**STAFF REPORT  
OF THE PLANNING DEPARTMENT  
FOR THE CITY OF BANDON, OREGON**

**FILE NUMBER:** 23-045

**REQUEST:** Approval of a conditional use permit to construct a new resort – 110 room hotel, two restaurant spaces, meeting rooms, and spa, as well as 32 villas/suites. Approval of a variance to certain height restrictions, and plan review for commercial design standards, parking, and signage.

*Figure 3. Proposed signage to be placed at the main entrance.*

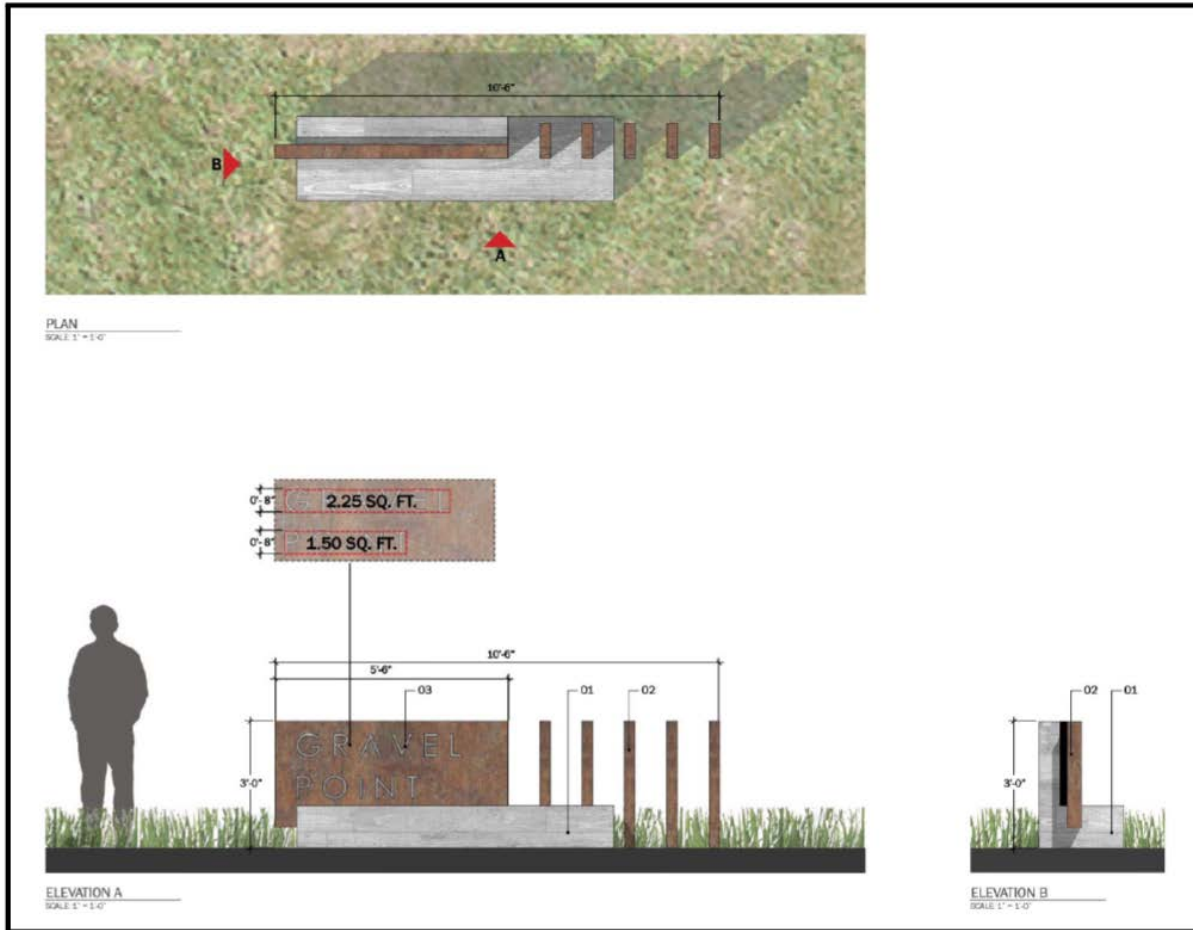
**Finding:** Consistent with BMC 17.90.080(B)(1), the applicant is seeking Planning Commission review and approval of the proposed signage associated with the Gravel Point development. The applicant has applied for concurrent review of a conditional use permit, variance, and plan review. The applicant is proposing three signs in total. One sign will be placed near the main entrance. The main entrance sign structure is 4-feet-6-inches in height with a length of 40-feet. The main entrance sign includes a series of angled monuments that give views of the natural landscape of the development. The actual lettering of the main entrance sign is 20-feet in length by 2-feet in height. The sign contains natural finishes that preserve the view of the natural landscape and enhance the visual character of the City. See Figure 3 below.

Figure 6. Proposed lighting fixtures.

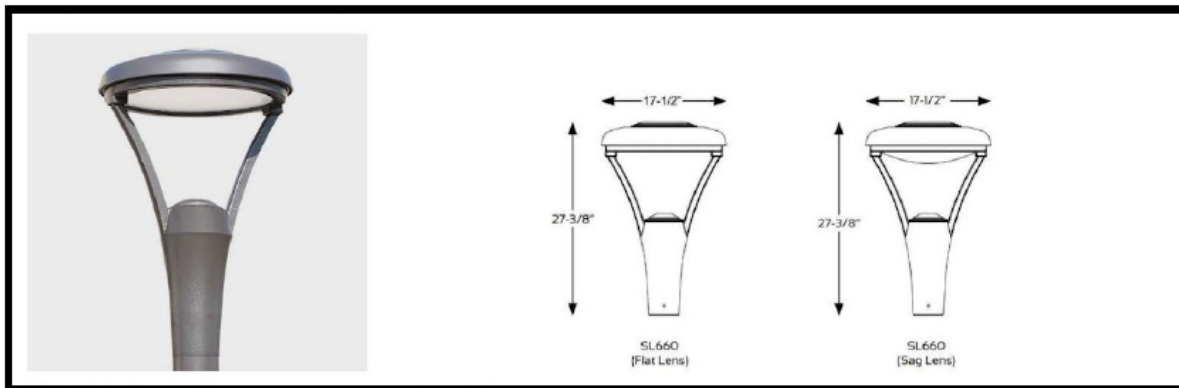
**FINDING:** All lighting fixtures will meet or exceed the City’s requirements. See images of proposed lighting plan below. The applicant’s plans show probable location of lights and that all lights will be shielded to avoid glare and skyward illuminations. The images of the proposed lighting fixtures demonstrate compliance.

*Figure 8. Proposed color and materials palette.*

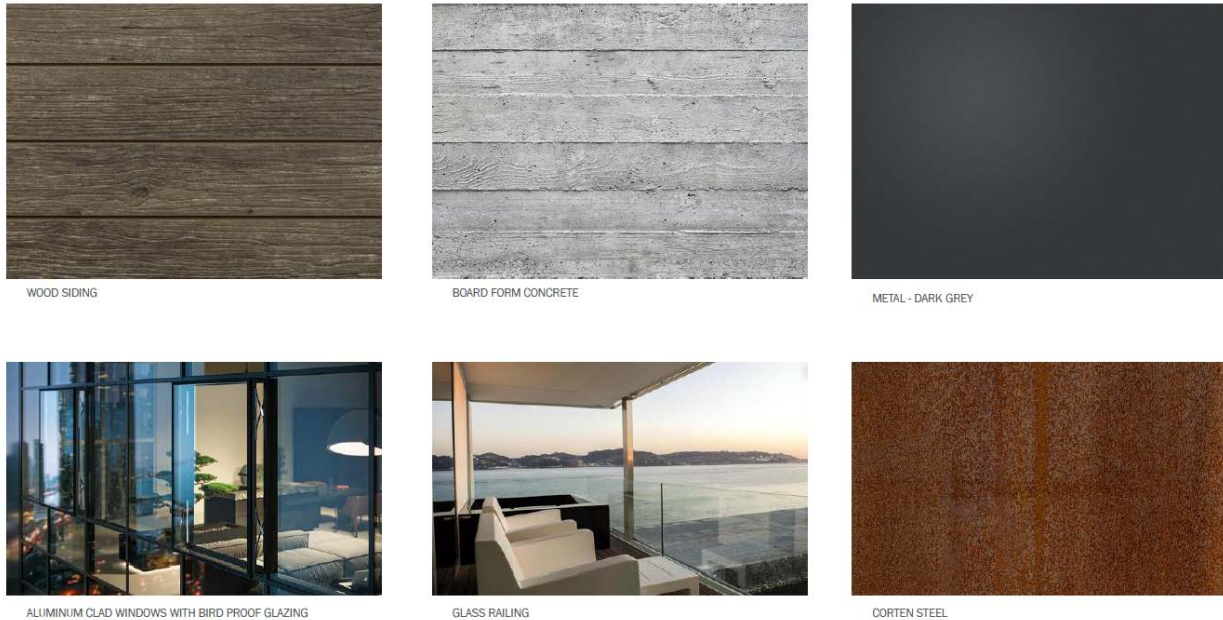
**FINDING:** As seen in the applicant’s plans, building materials include wood siding, board form concrete, corten steel, glass railings and aluminum clad windows with bird proofing. The color palette is proposed as seen in the image below and appears to meet the spirit and intent of the materials and colors code standard. Criterion met.

Figure 9. Bandon Local Wetlands Inventory.

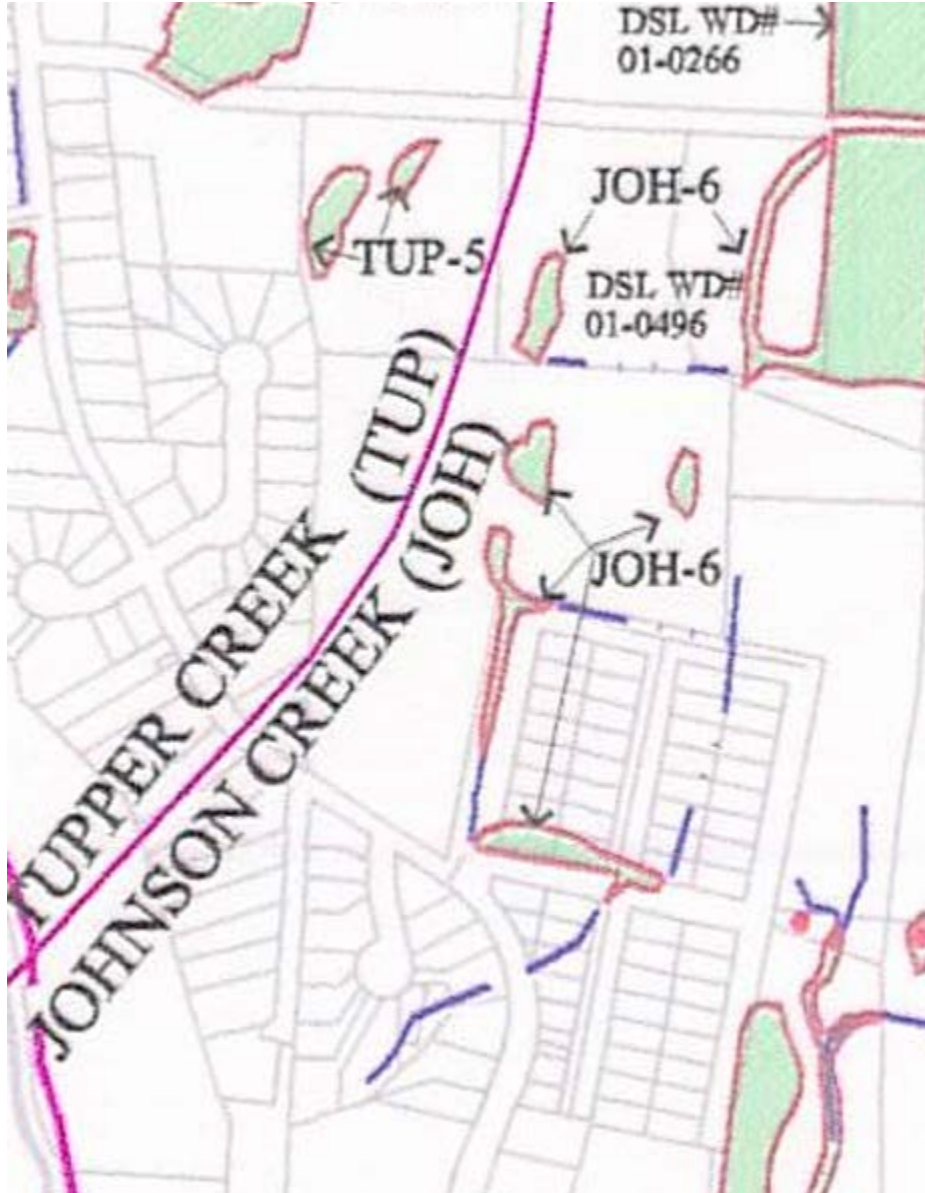
The proposed project site does contain wetlands as indicated on the map below. The City uses the adopted, "Bandon Local Wetlands Inventory" map to determine when there are wetlands present (see below) and uses the inventory to determine their significance. The relevant inventory documents have been attached to this staff report and show that these are not significant wetlands.

The applicant states that the National and Local wetland maps are inconsistent and that they prepared a delineation to determine where the wetlands are located. This delineation was not submitted to the City as part of this review. The City's wetland map supersedes the national inventory as the information is more specific and adopted by our code. The State's aquatic resource planner has stated: Bandon has an LWI [Local Wetland Inventory], and LWIs supersede the SWI [State Wetland Inventory] for WLUN [Wetland Land Use Notification] and Goal 5 planning.
